Report to the Future Melbourne Committee

**Ministerial Planning Referral: TPM-2020-1
68-102 and 103 Alfred Street, and 87-105 Racecourse Road, North Melbourne**

MINISTERIAL PLANNING REFERRAL**DELEGATED REPORT**

Application number:	TPM-2020-1
DELWP application number:	PA1900752
Applicant:	Pace Development Group
Owner:	Racecourse Road North Melbourne
Architect:	Hayball Architects
Address:	68-102 and 103 Alfred Street and 87-105 Racecourse Road, NORTH MELBOURNE VIC 3051
Proposal:	Construction of multiple multi-storey mixed-use buildings plus basements and rooftops for dwellings, retail, office, childcare and a reduction of car parking
Cost of works:	\$135,000,000
Date of application:	7 January 2020
Responsible officer:	Michelle Fernando, Urban Planner

Figure 8b – Section showing extent of non-compliance with DDO63 upper level setbacks Bldg D

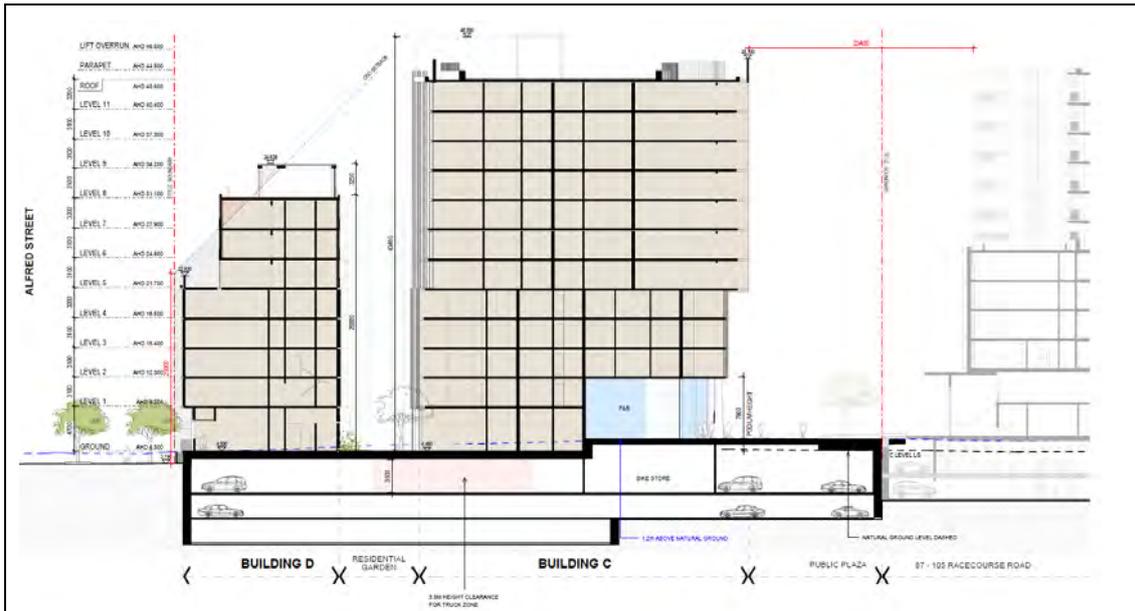
Building D has a street wall height of 20.2 metres; upper levels are setback between 4.7 – 13.15 metres. Building D has been stepped back and punctuated with balconies as it moves to the east, this assists in reducing the overall visual bulk associated with the continuous form. The proposed variation to the upper level setbacks is supported; however it noted that issues with overall height and massing as discussed earlier remain.

Figure 11 – Interface with Pleesey Place within Stage 1 and 2 to the north

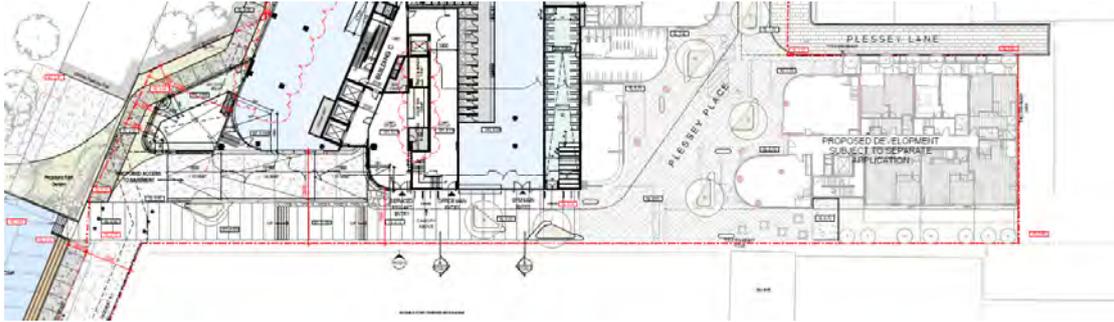
It is noted that the laneway provisions on pages 6 and 7 of DDO63 differ from those in Table 3 to DDO63 and state that development along new and existing laneways and pedestrian connections must comply with the laneway controls in Table 3.

Figure 12 – Public interface at which development stages 1, 2 and 3 intersect

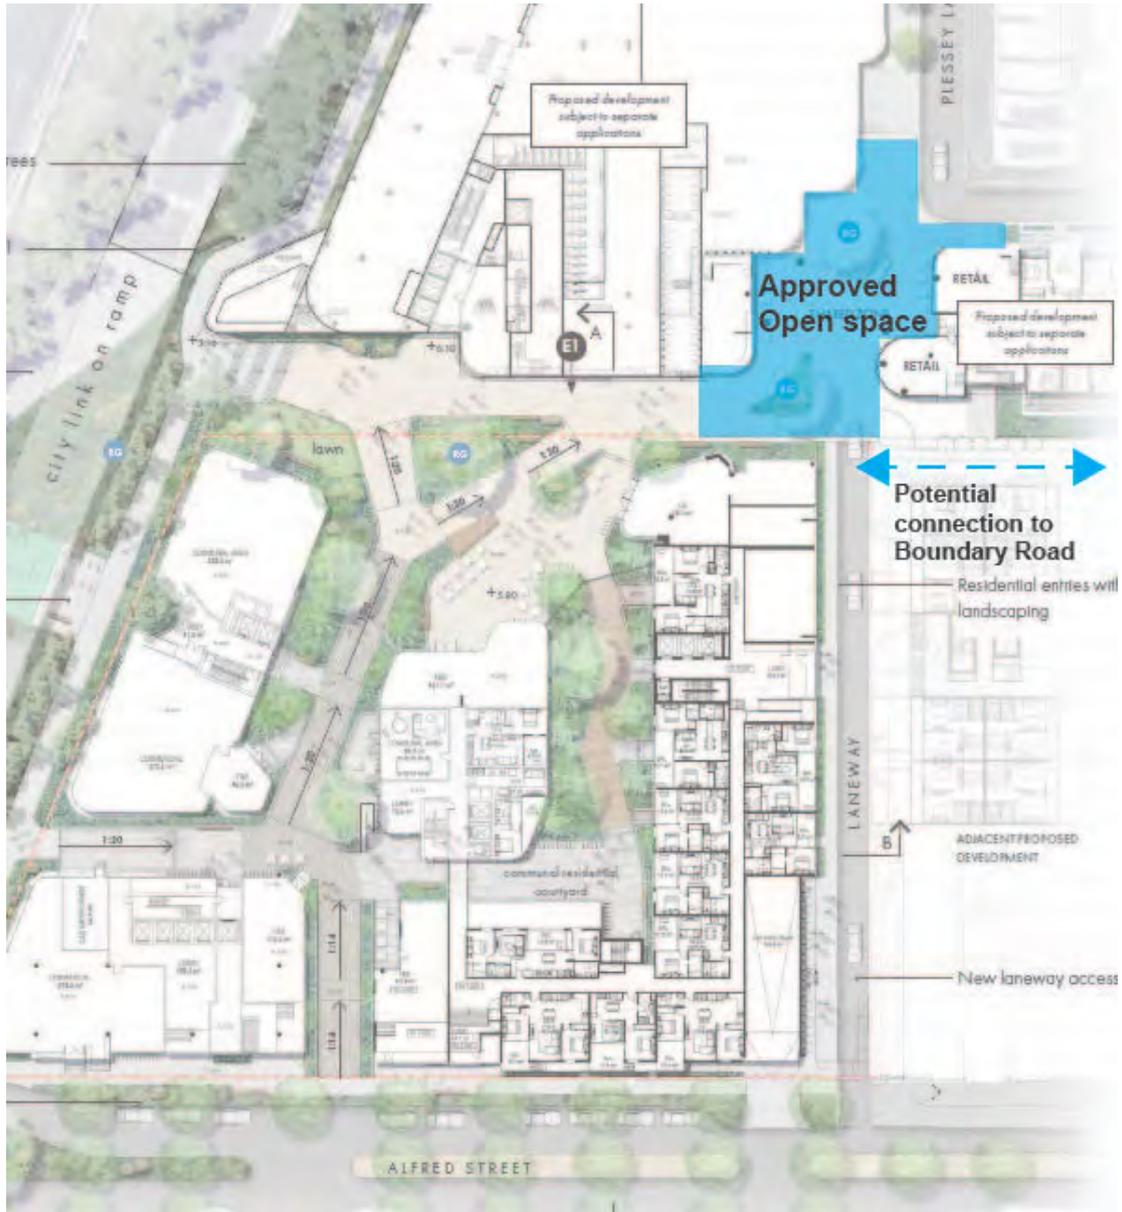
Similarly northern and eastern boundary has provided publically accessible spaces in accordance with abutting sites. Council's Urban Designer has recommended the northeast of Building D is better integrated with approved open space on adjoining sites.

Figure 14 – Proposed façade treatment to Building C

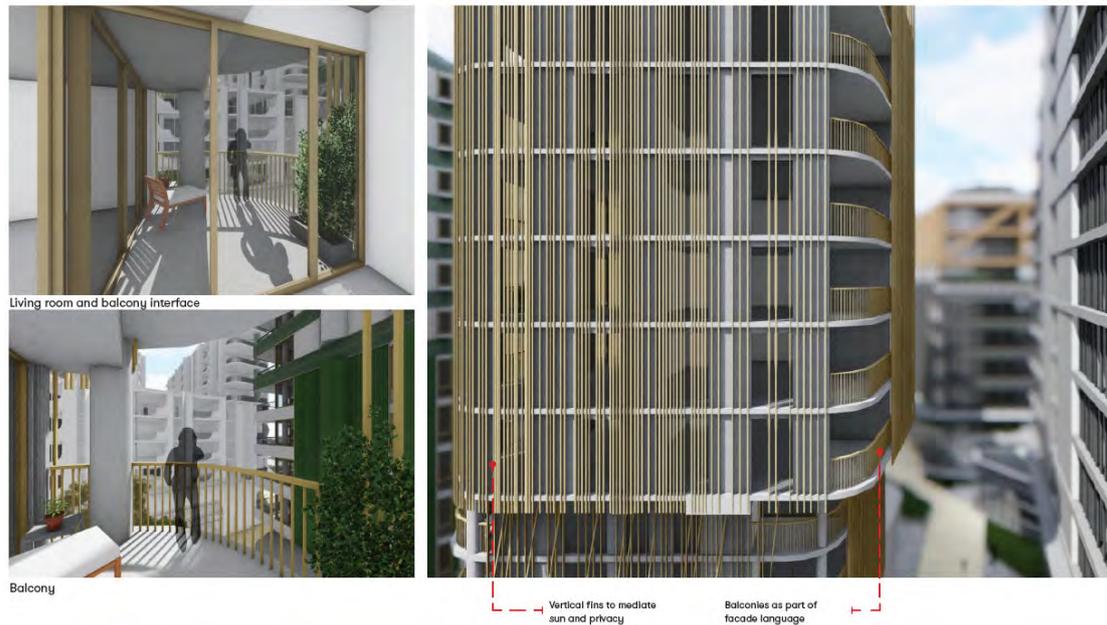
other dwellings within the development. Building C is also proposed to be clad in vertical fins to mediate sun and privacy issues. The reliance on screening to mitigate impacts of limited building separation is considered to be a poor response.

Figure 15 a– Southern interface of Stage 1 and layout of Plessey Place

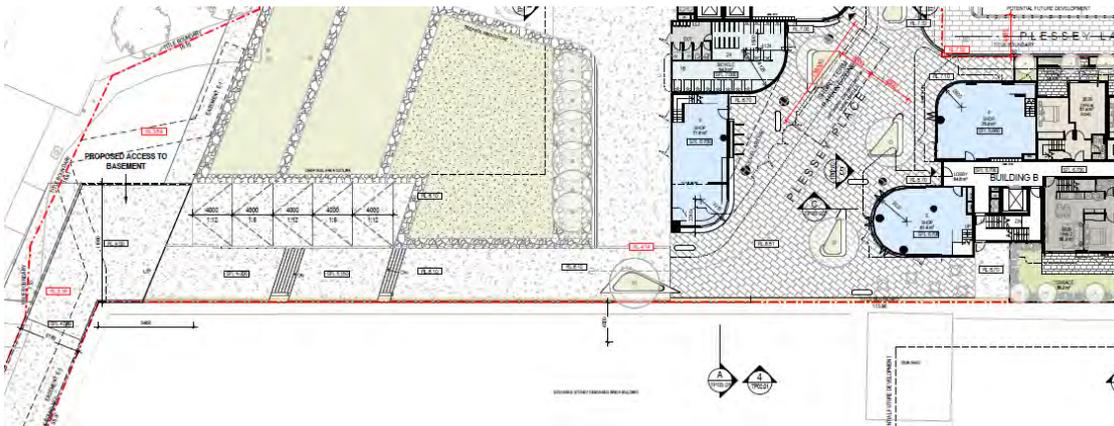
It is noted that the alignment of proposed eastern boundary laneway does not accord with development to the north. Further information including plans showing proposed pedestrian and vehicle movements is required.
